## DESCRIPTIVE REPORT (HYDROGRAPHIC)

Type of Survey ..... HYDROGRAPHIC  
..... AHP-20-1-75  
Field No. ....  
Office No. .... H-9338

LOCALITY  
State ..... FLORIDA  
General Locality ..... WEST COAST  
Locality ..... APPROACHES TO TAMPA BAY

DESCRIPTIVE REPORT  
TO ACCOMPANY  
HYDROGRAPHIC SURVEY H-9338  
AHP-20-1-75

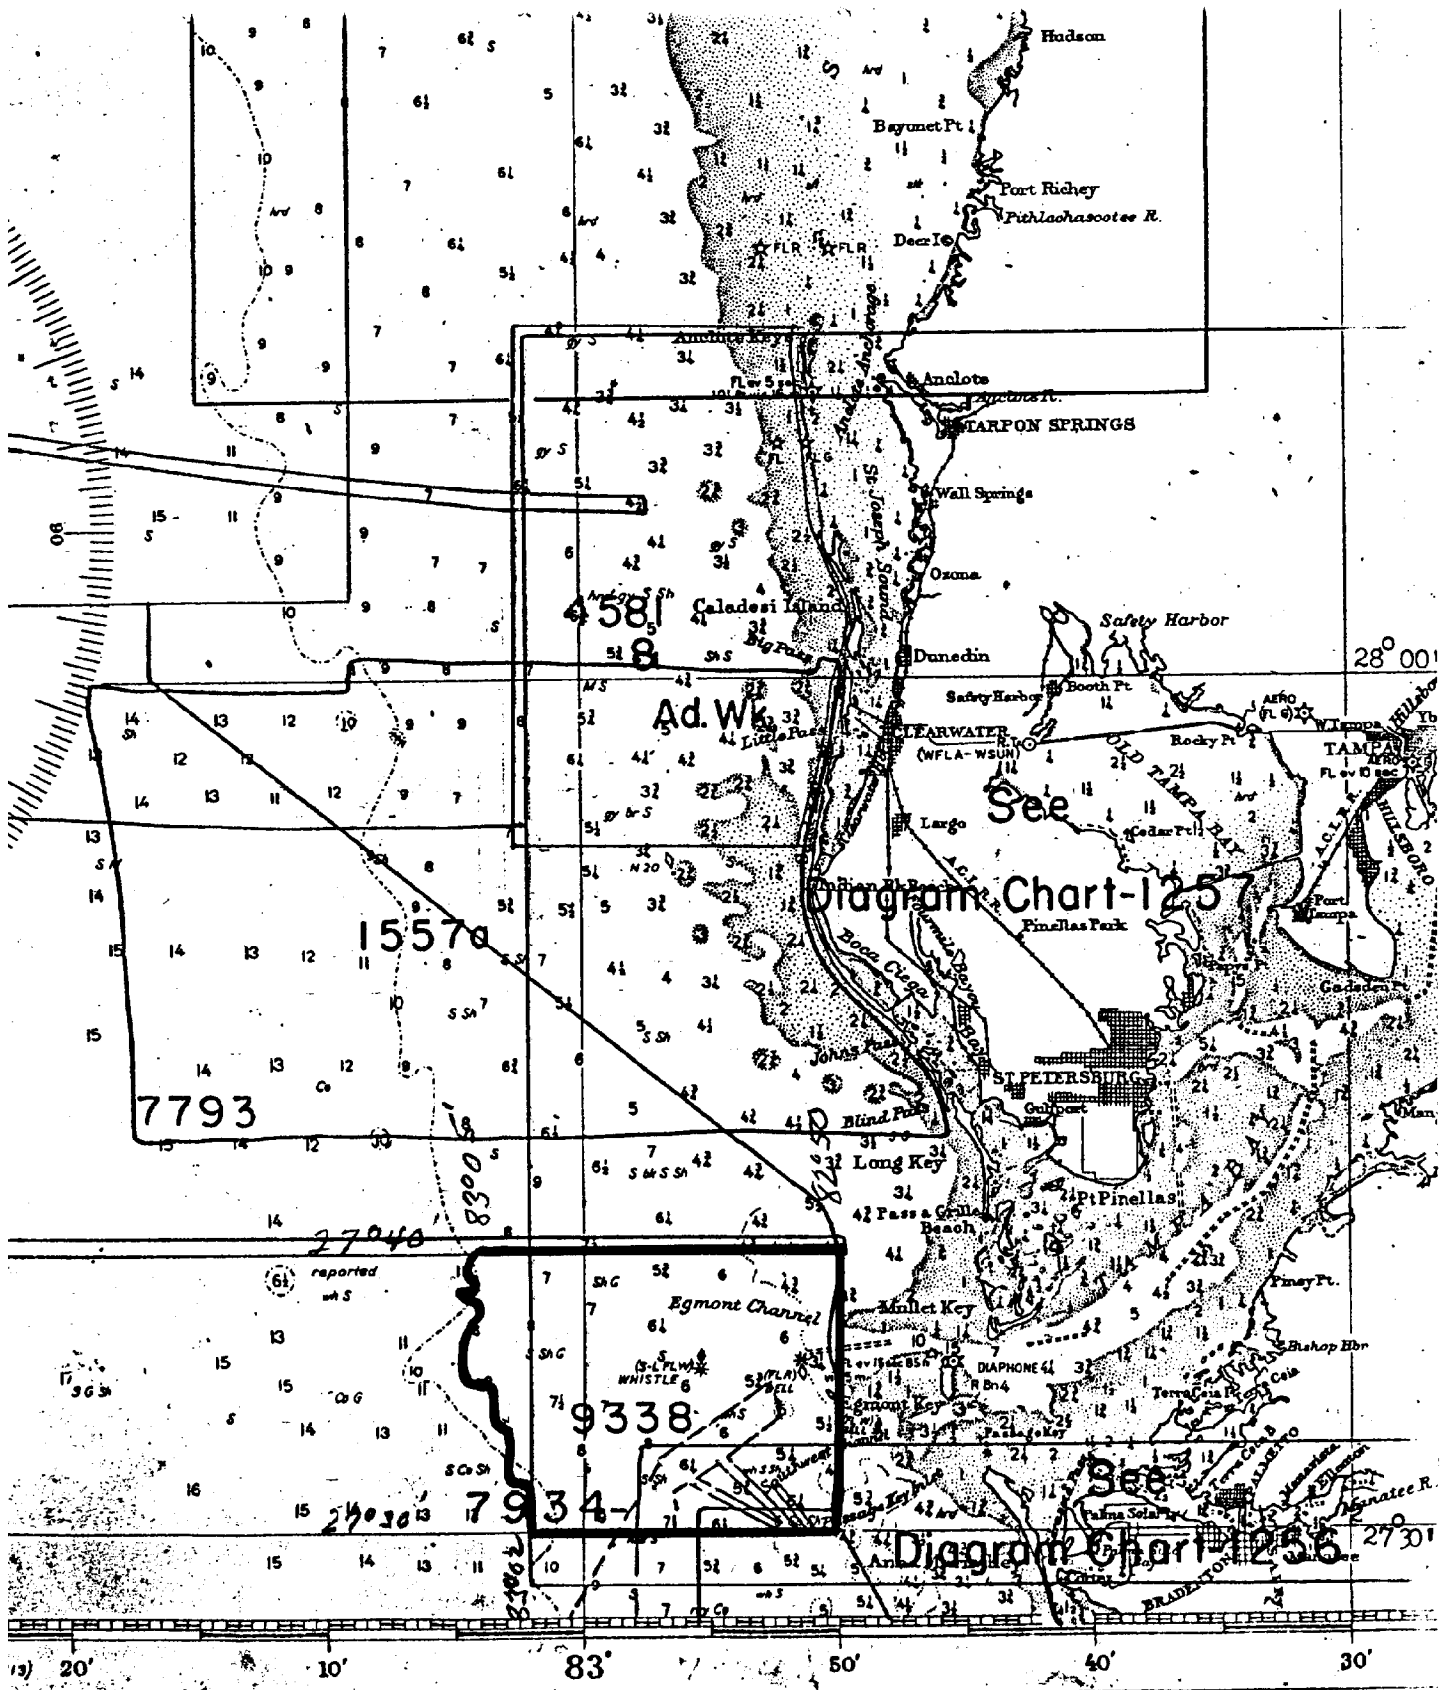
2. Section 7 of the Verifier's Report (Comparison with Charts) is lacking any reference to the results of a comparison between the present survey and the controlling depths of the charted channel in the survey area (Egmont Channel).

Section 7 of the Verifier's Report is supplemented by the following:

B. Controlling Depths

The controlling depths of Egmont Channel on the present survey (38 feet) exceed those indicated in the charted tabulation.
